RENESAS TECHNICAL UPDATE

Product Category	MPU&MCU		Document No.	TN-SH7-A668A/E	Rev.	1.00
Title	SH7764 Power-on/Power-off sequence correction		Information Category	Technical Notification		
Applicable Product	R5S77640P300BG	Lot No.	Reference Document	SH7764 Group Hardware Manual (REJ09B0360-0100)		
	R5S77640D300BG	All lots				
	R5S77640N300BG					
	R5S77641P300BG					
	R5S77641D300BG					
	R5S77641N300BG

Figure 33.1 Power-on/Power-off Sequence

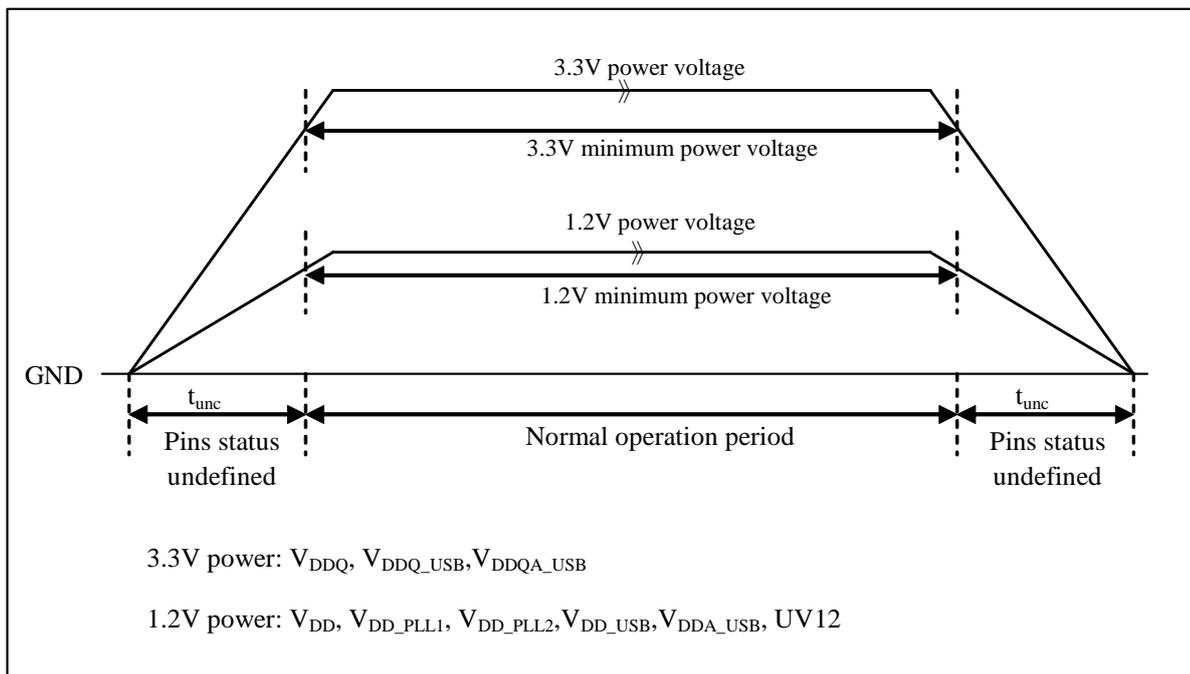
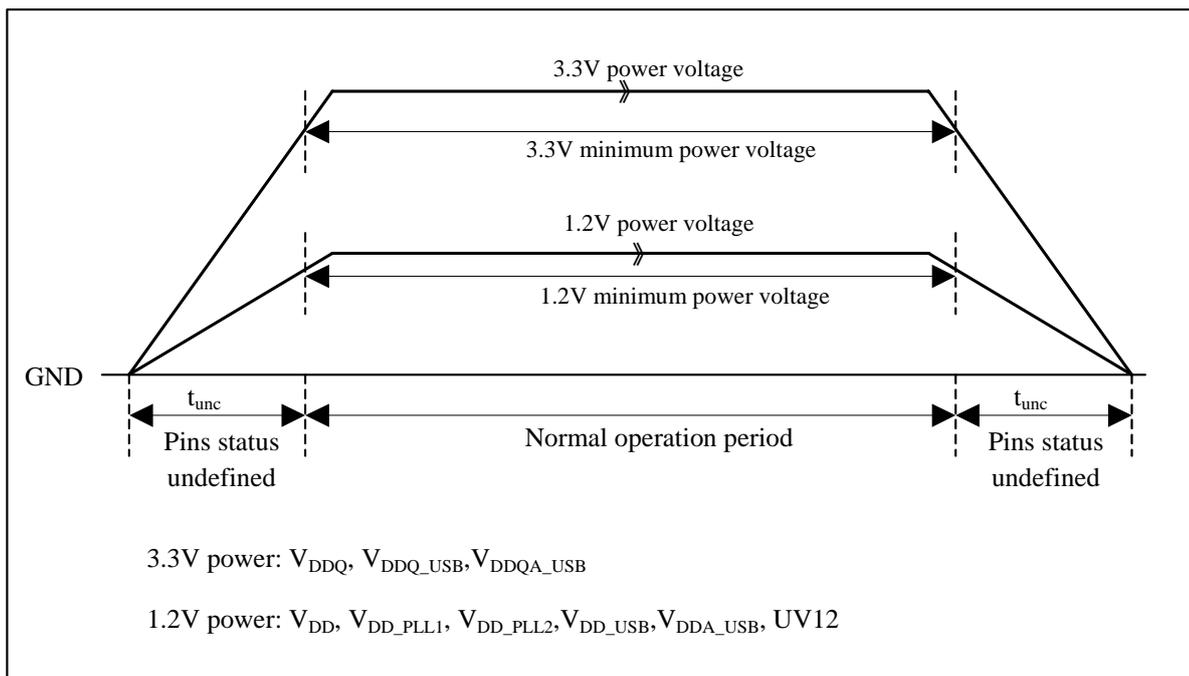
1. Correntions on “33.2 Power-on/Power-off Sequence” (page 1574)

Either the 3.3-V power supply or the 1.2-V power does not matter to be turned on or turned off. An undefined time appears until either of the power supply, which turns on later, reaches above the minimum voltage and after it has reached below the minimum voltage. During these periods, pin and internal states become undefined. Design the system so that these undefined states do not cause an overall malfunction.

Either the 3.3-V power supply or the 1.2-V power does not matter to be turned on or turned off for this LSI device operation. An undefined time appears until either of the power supply, which turns on later, reaches above the minimum voltage and after it has reached below the minimum voltage. During these periods, pin and internal states become undefined. Design the system so that these undefined states do not cause an overall system malfunction. For designing system, recommends that 1.2-V power is turned on before turning on 3.3-V power in power-on sequence and 3.3-V power is turned off before turning off 1.2-V power in power-off sequence. And then recommends that 3.3-V power is turned on as quick as possible after 1.2-V power reaches approximately 0.6V level in power-on sequence. Nevertheless when 3.3-V power needs to be turned on before turning on 1.2-V power, time period between turning on 3.3-V power and 1.2-V power reaching approximately 0.6V level should be considered to be shortened as much as possible.
